Southern Utah Wilderness Alliance
Petition for Review
UIC Permit UT22291-10328

Response To Public Comments
On
EPA Permit Number: UT22291-10328
for
RBU 1-10D Class II Enhanced Oil Recovery Well
in the
River Bend Unit
Uintah County, Utah

Issued to
Gasco Energy, Inc.

Subject: Comments on Draft Underground Injection Control Permit UT22291-10328, Class II Enhanced Oil Recovery Well, RBU 1-10D, API No.: 43-047-34312, Uintah County, UT

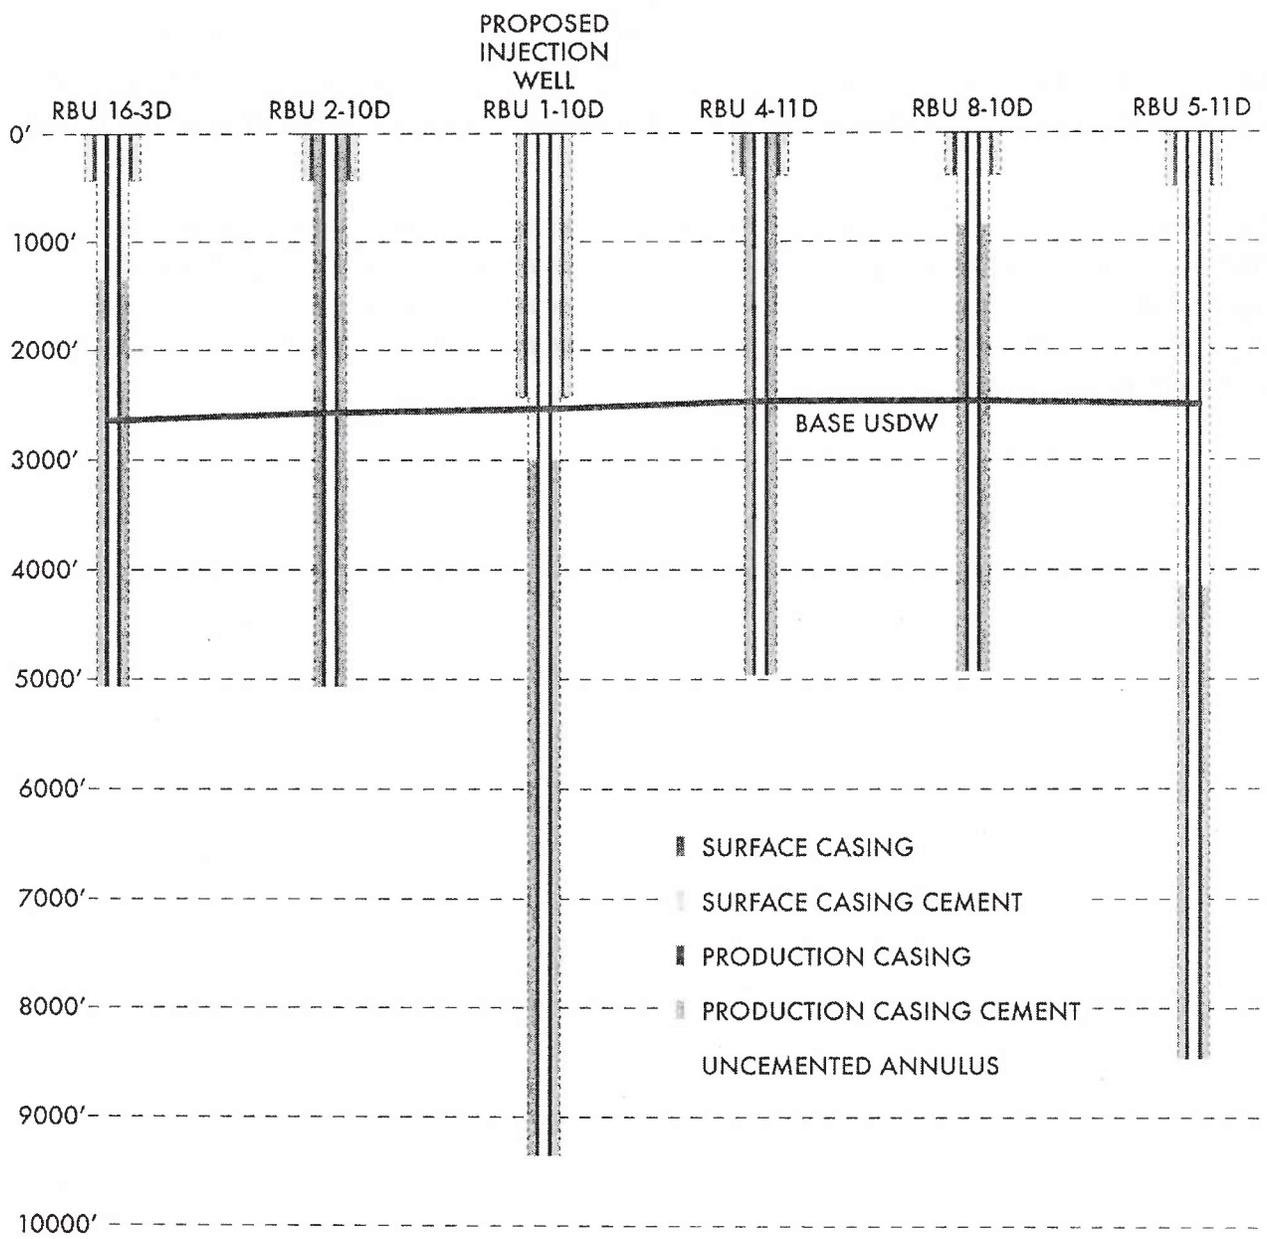
In the permit application, the base of the deepest USDW in the proposed injection well is estimated at 2523 feet. However, the surface casing, which is intended to isolate and protect usable groundwater, is set at 2414 feet. Furthermore, the top of cement behind the production casing is estimated to be at 2980 feet. In other words, the surface casing does not extend below the base of the USDW and the production casing cement does not extend above the base of either the USDW or the surface casing. This means that a portion of the annular space adjacent to the USDW is uncemented. Leaving this annular space uncemented puts both the USDW and well integrity at risk.

The surface casings for the wells identified in the permit application as being within or near the ¼-mile AoR are set significantly shallower than the surface casing in the proposed injection well. The permit application does not specify the depths to the base of the USDW for these wells. However, a review of the map of the Base of Moderately Saline Ground Water ("BMSW")², which, as stated in the draft permit, "corresponds to the base of the USDWs in the area," indicates that the BMSW in these offset wells is likely to be at similar depths as the BMSW in the RBU 1-10D, or approximately 2500 feet. The surface casing in all five listed offset wells does not extend below the base of the USDW.

As with the RBU 1-10D, in three of the five offset wells, the top of the production casing cement does not extend above the base of the surface casing. In one such well, the RBU 5-11D, the top of the production cement also does not extend above the base of the USDW. In this well, the base of the surface casing is at 500', the base of the USDW is at approximately 2500', and the top of the production casing cement is at 4160', meaning that almost 1650 feet of wellbore behind the production casing is uncemented.

Failing to extend surface casing in any well to below the base of the lowest USDW puts those USDWs below the base of the surface casing at significant risk of contamination. Cross flow may occur between the USDW and other formations, potentially leading to contamination of the USDW. Leaving a potential flow zone uncemented can also result in overpressurization of the annulus and/or result in casing corrosion, both of which may lead to a well integrity failure, further putting drinking water at risk. Properly constructed wells typically have at least two barriers between USDWs and fluids contained in the well: 1) the surface casing and 2) the

EPA Response: It appears that the commenter is concerned with a potential for mechanical integrity issues to arise due to the way this well will be cemented. Mechanical integrity is defined at 40 CFR 146.8. The commenter's concerns are in regard to the second prong of this definition. This says that "an injection well has mechanical integrity if: there is no significant fluid movement into an underground source of drinking water through vertical channels adjacent to the injection well bore." 40 CFR 146.8(a)(2). The regulations further describe the methods that must be used to determine the absence of significant fluid movement. 40 CFR 146.8(c). In this case, EPA has determined that the applicant has adequately demonstrated mechanical integrity via 40 CFR 146.8(c)(2).

EPA Region 8 Groundwater Section Guidance Number 34 (<http://www2.epa.gov/sites/production/files/documents/R8UIC-GUIDE34.pdf>), in the evaluation of well Mechanical Integrity, instructs permit reviewers to review the well's Cement Bond Log (CBL) to determine the adequacy of the cement to prevent fluid migration under 40 CFR 146.8(c). The CBL must show a Cement Bond Index (CBI) of at least 80% for a span of 18 consecutive feet (for 5 ½ inch pipe) in the injection zone's overlying confining zone. This will verify that seepage is unlikely to occur, between the injection zone and any adjacent USDWs. The top of cement is above the confining zone, and there is no requirement for it to go above the bottom of the surface casing. The base of the USDW is covered under Appendix E, Plugging and Abandonment Requirements.

Since a greater than 80% CBI could not be confirmed by the analysis of the CBL in this case, the operator is additionally required, as part of the permit, to determine the absence of significant fluid movement into a USDW through vertical channels adjacent to the injection well bore by conducting a Radioactive Tracer Test (RTS) as a procedure to identify the presence or absence of vertical fluid movement behind the casing near injection perforations. The RTS is used to supplement data from approved Part II demonstrations. If channeling behind casing is detected, the RTS can also be used to evaluate the
